**RE: Review of Form 28 Centralized E&P Waste Management Facility Permit  
Facility ID #441234, De Beque Water Station  
Black Hills Exploration and Production  
SESE Section 29, T8S, R97W, 6<sup>th</sup> PM, Mesa County, Colorado**

In response to your comment letter dated May 4, 2015, we have prepared additional information for the above-referenced project to address COGCC's comments and concerns. All comments that had a COGCC Comment of "None" were not addressed in our responses. The following information reiterates your comments and our specific responses to each comment as follows:

## **OIL SKIMMING DETAILS**

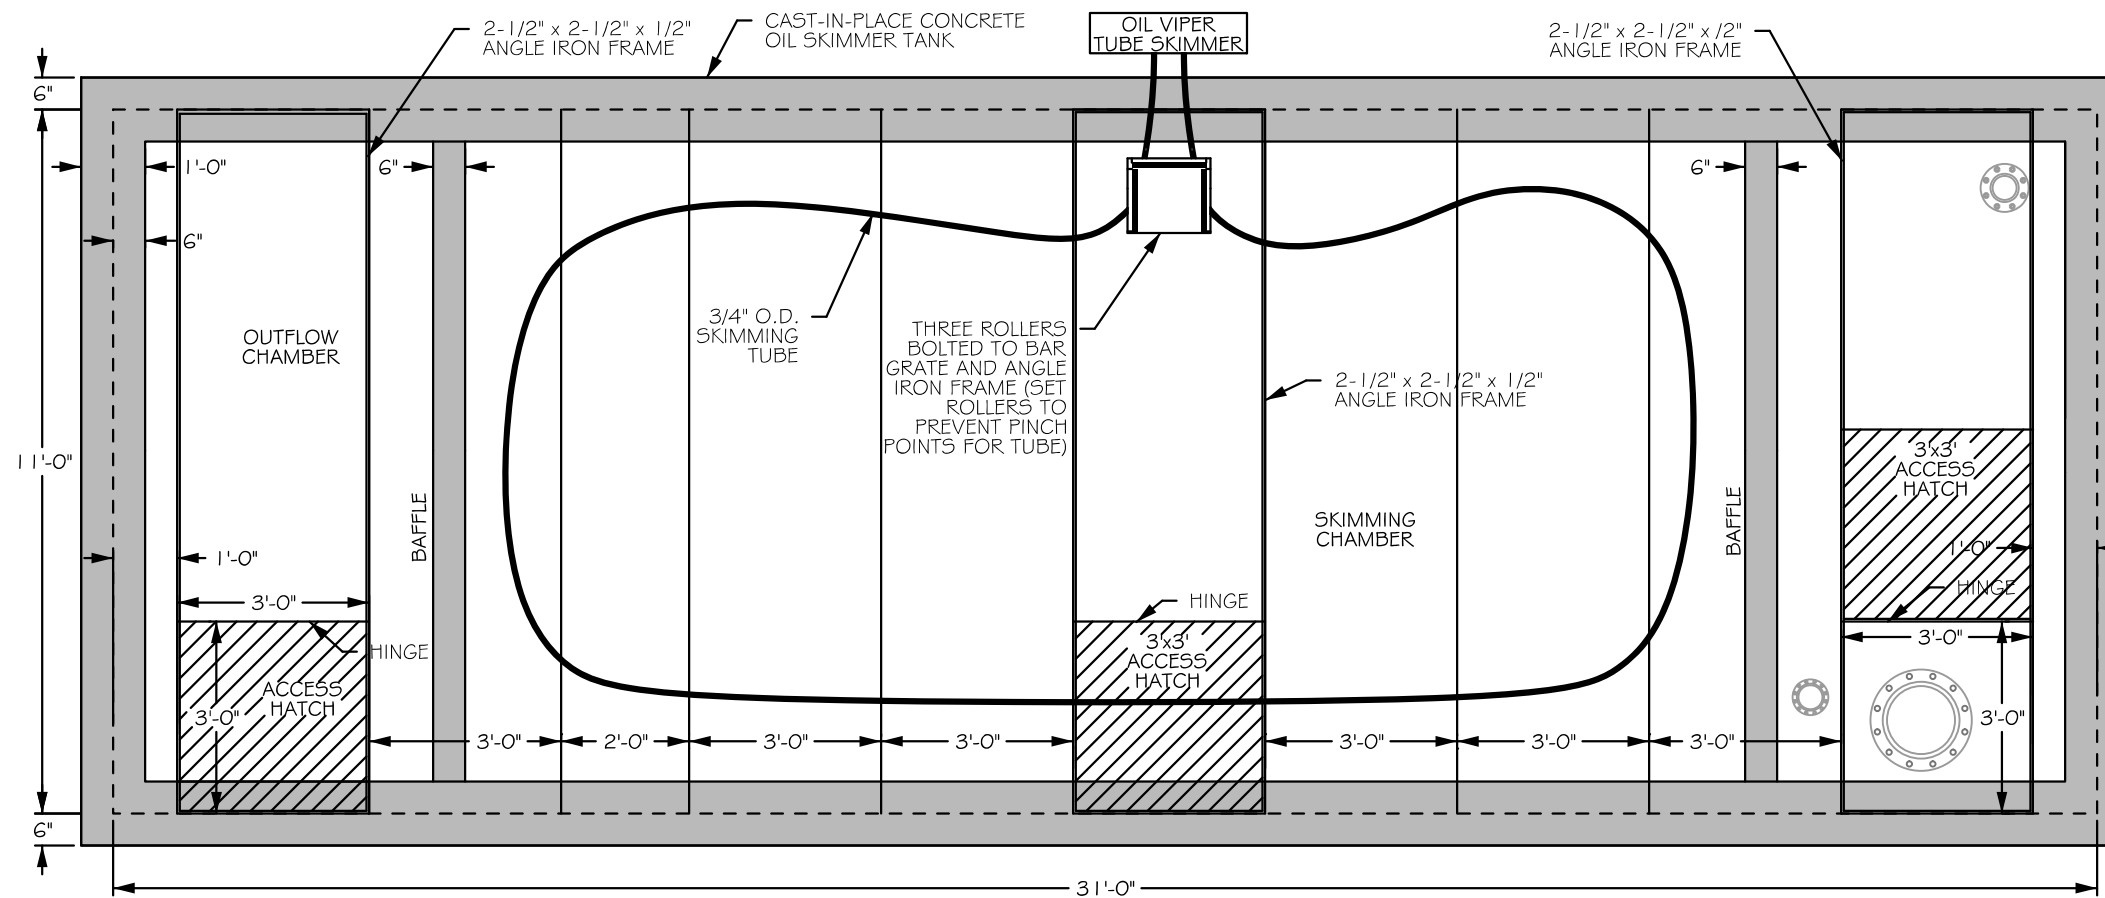
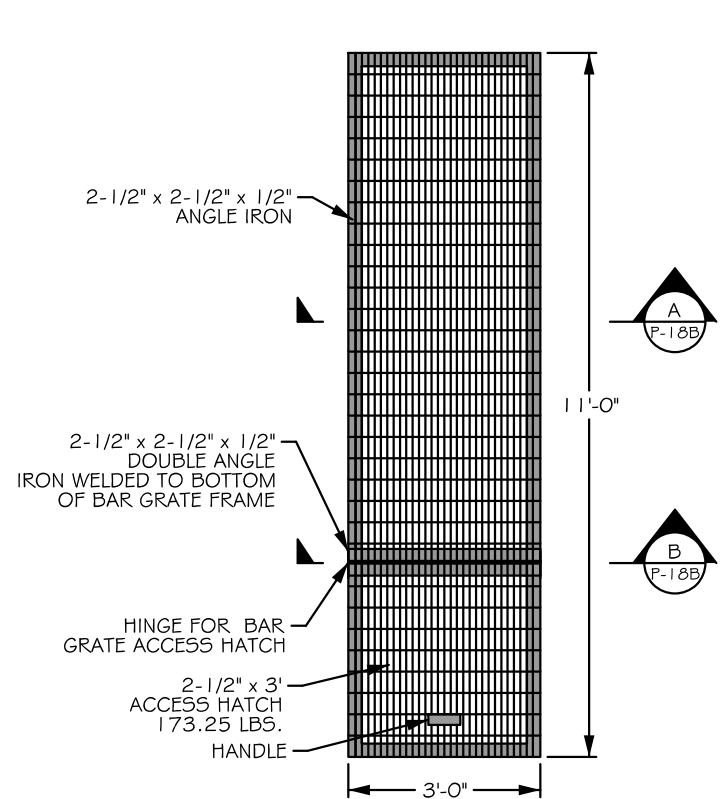
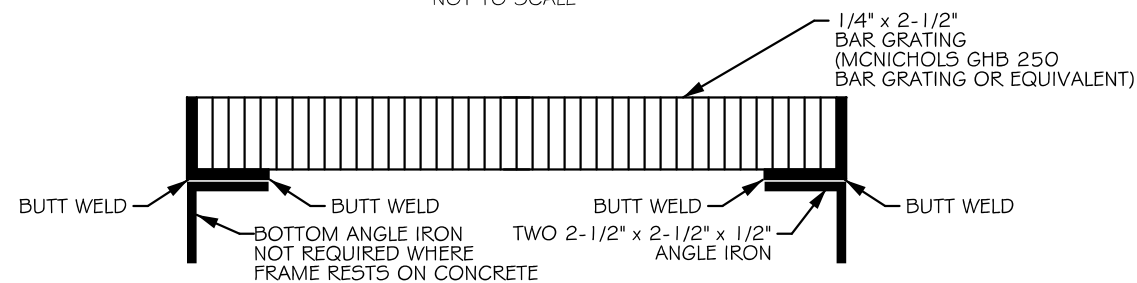
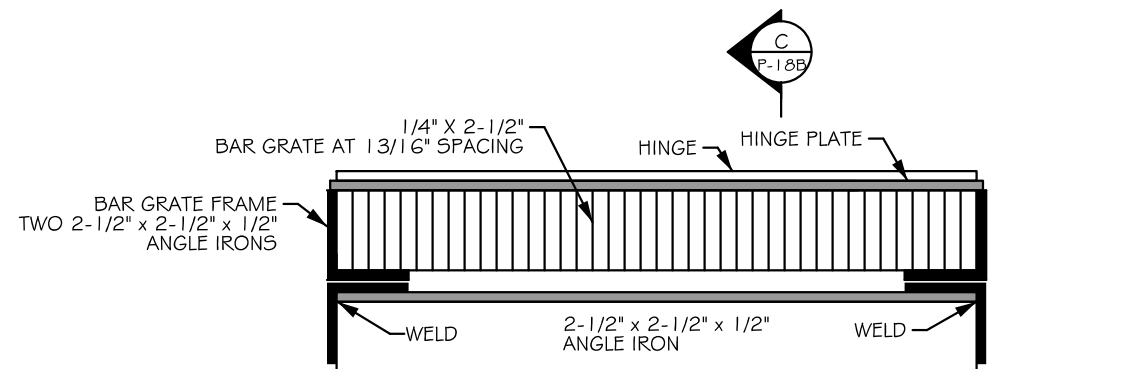
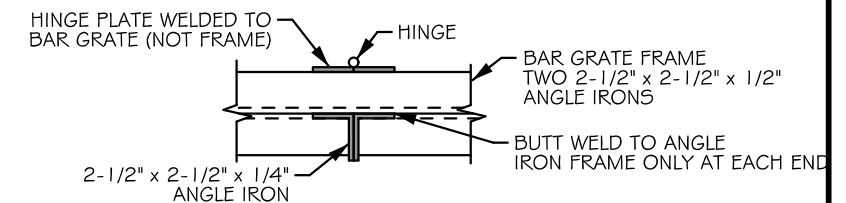
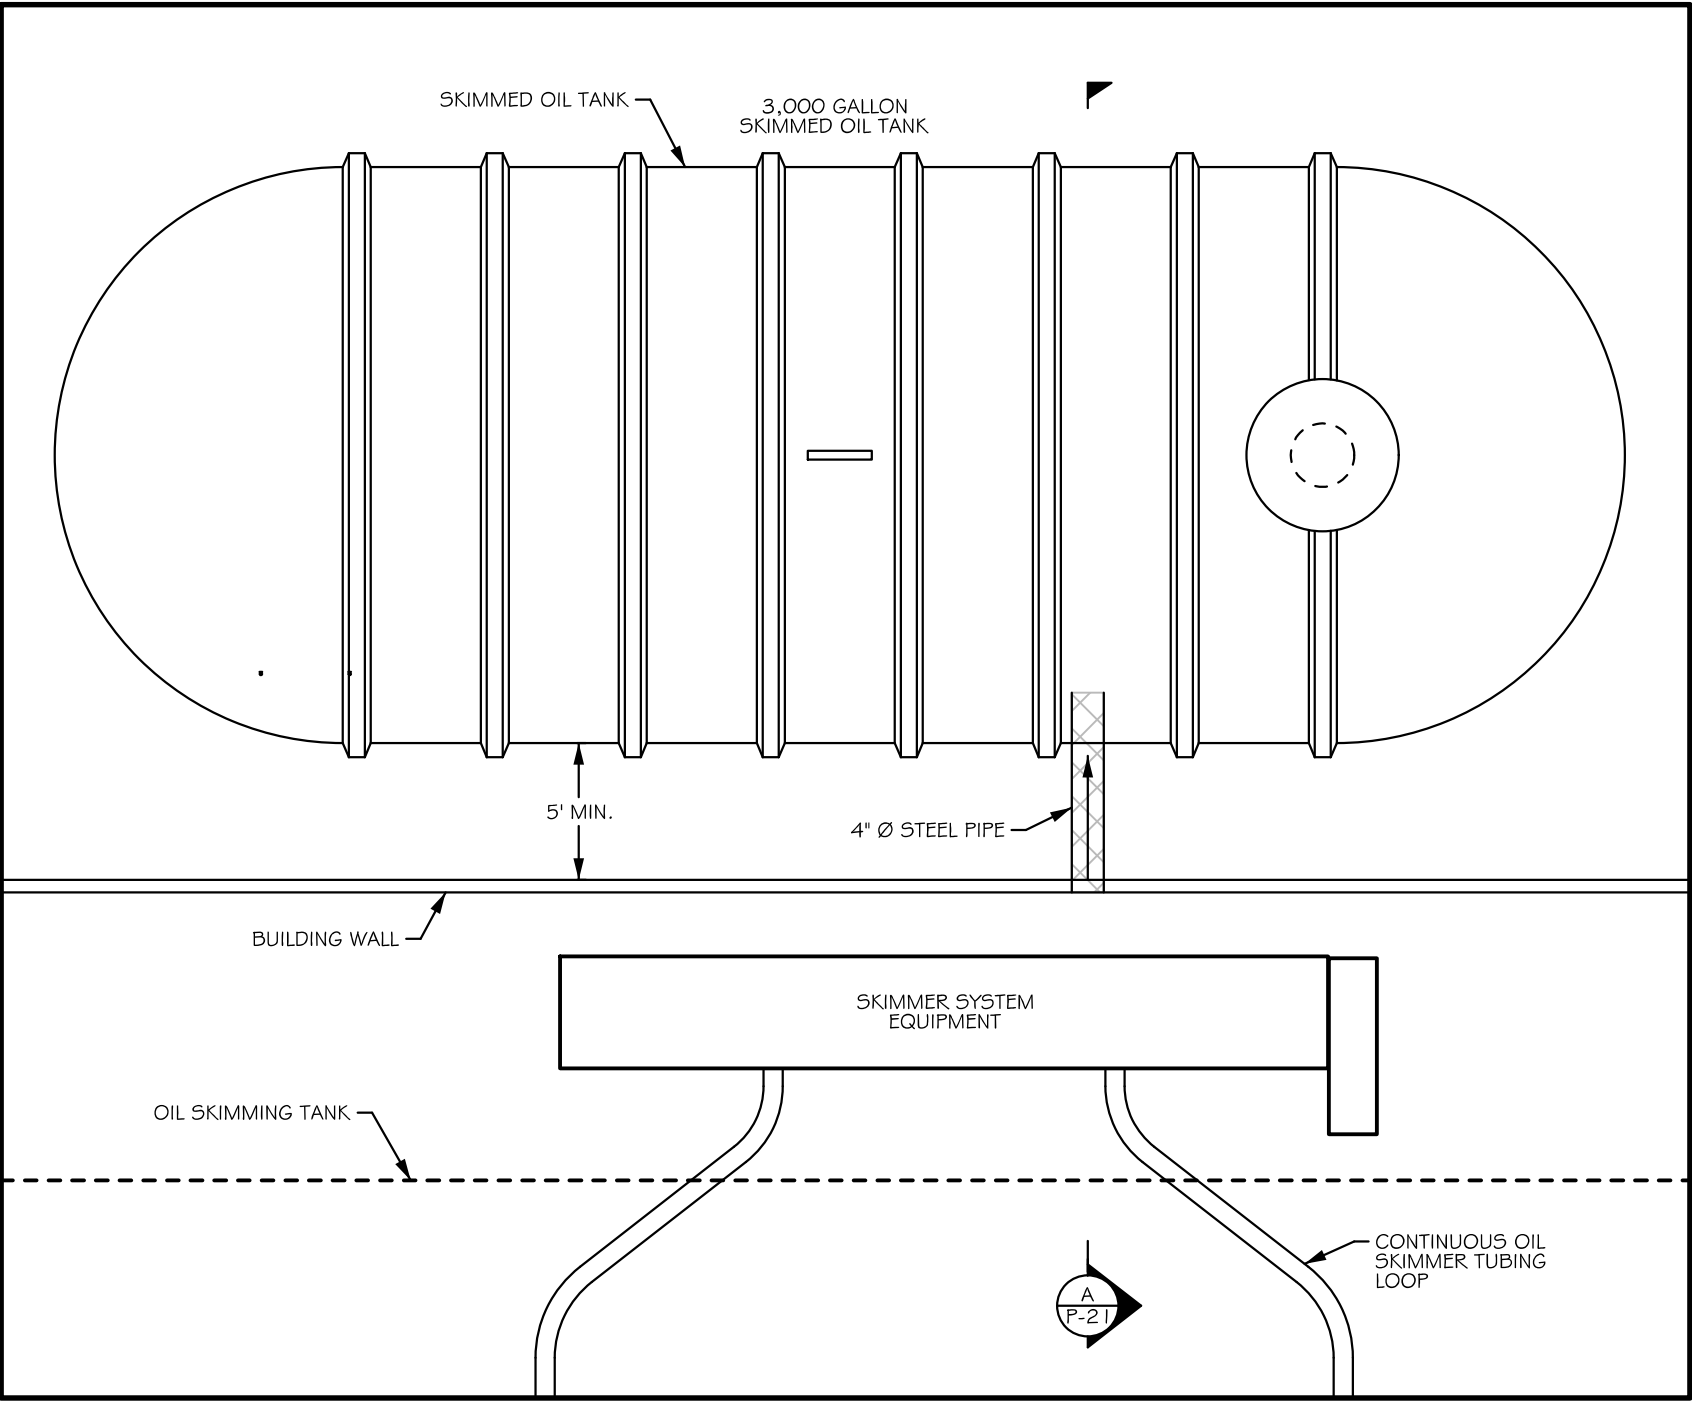
- What is the capacity of the skimming chamber?
- What is the capacity of the buried tank (underground storage tank, UST)?
- What are the design elements of the UST?
- Does this UST need to be permitted by other agencies or entities?

Provide the location of these features on the Facility Layout drawing.

Provide detail of the skimming chamber and UST.

- *The oil skimming chamber has inside dimensions of 30 feet long by 10 feet wide by 7 feet high. The tank has 2 feet of freeboard and has a water surface depth of 5 feet. There is an overshot and undershot baffle integrated into the skimming chamber. See the skimming chamber detail located in Attachment B. The capacity of the skimming chamber is 1,460 cubic feet or 350,000 gallons.*

- *The capacity of the UST is 3,000 gallons to store skimmed condensate.*
- *The UST is 16'-9" long and has an inside diameter 6'-0". See the drawings and product shop drawing submittal located in Attachment B.*

- *A facility layout drawing has been included in Attachment B showing the skimmed oil tank located on the north side of the pump station building. The oil skimming chamber is located inside the pump station building in the northwest corner and is represented by the dashed lines.*

***Response: Details of the oil skimming chamber and UST have been included in Attachment B.***

Truck Load/Unload Details  
SHEET  
P-23

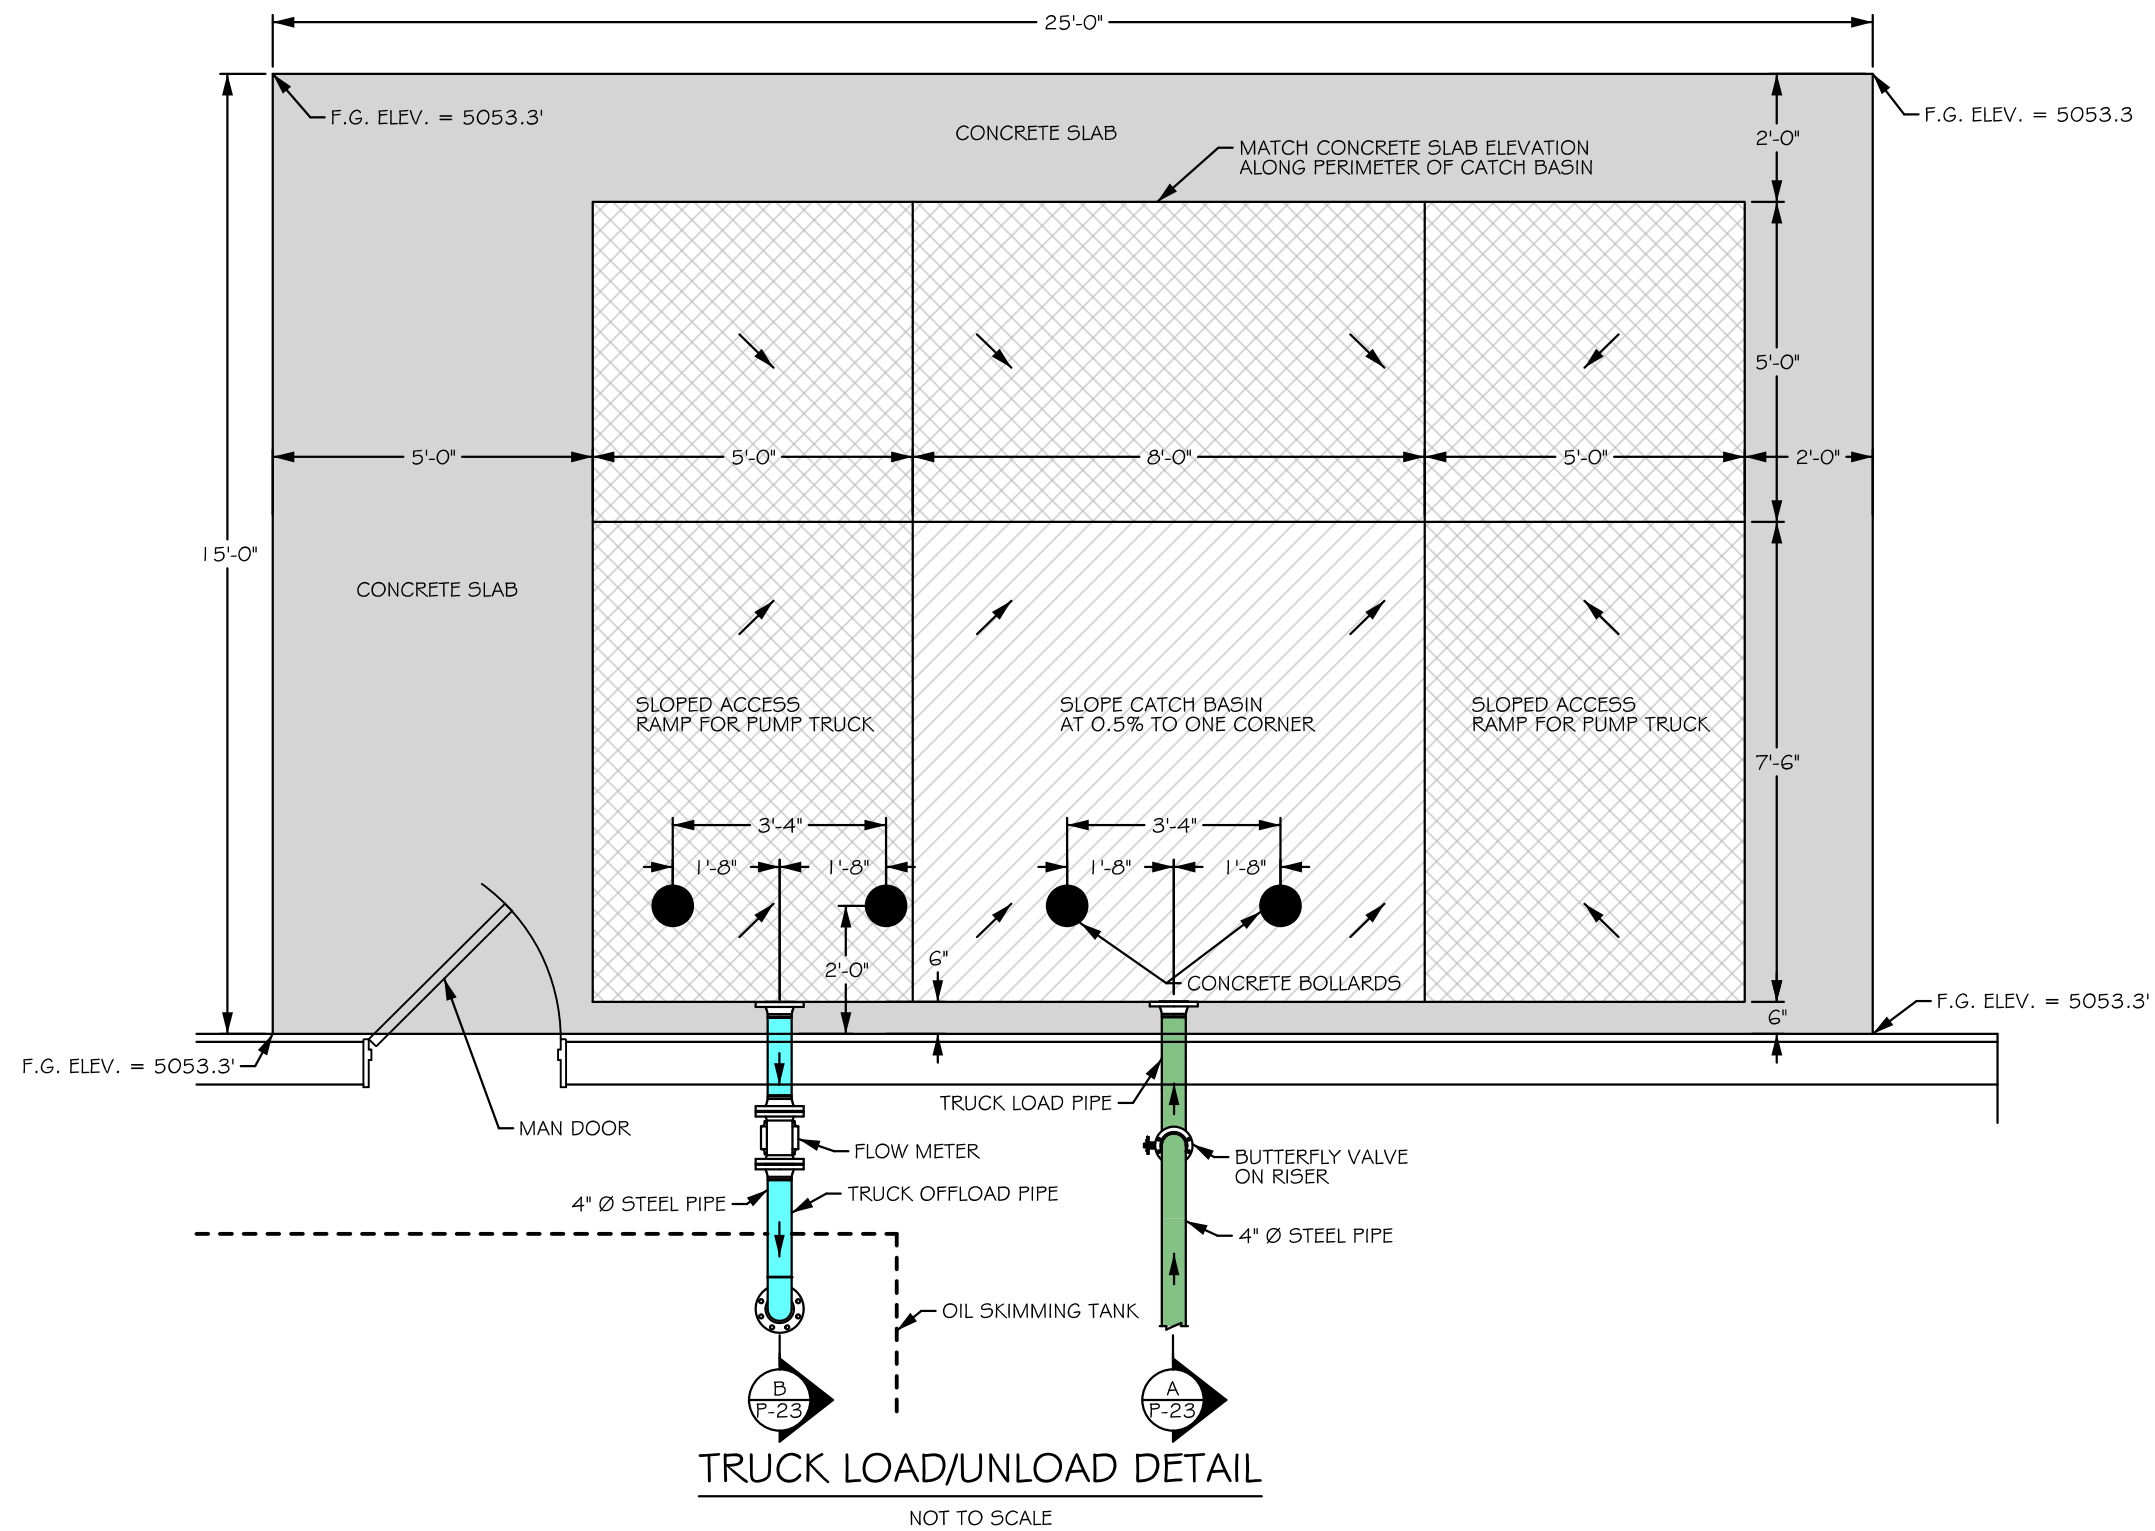
**COGCC Comment:** Provide schematic and location of truck load out.

***Response: A schematic of the truck load out has been provided in Attachment F. The truck load out is located on the north side of the pump station pump and is adjacent to the UST. See the floor plan in Attachment B for the truck load out location.***
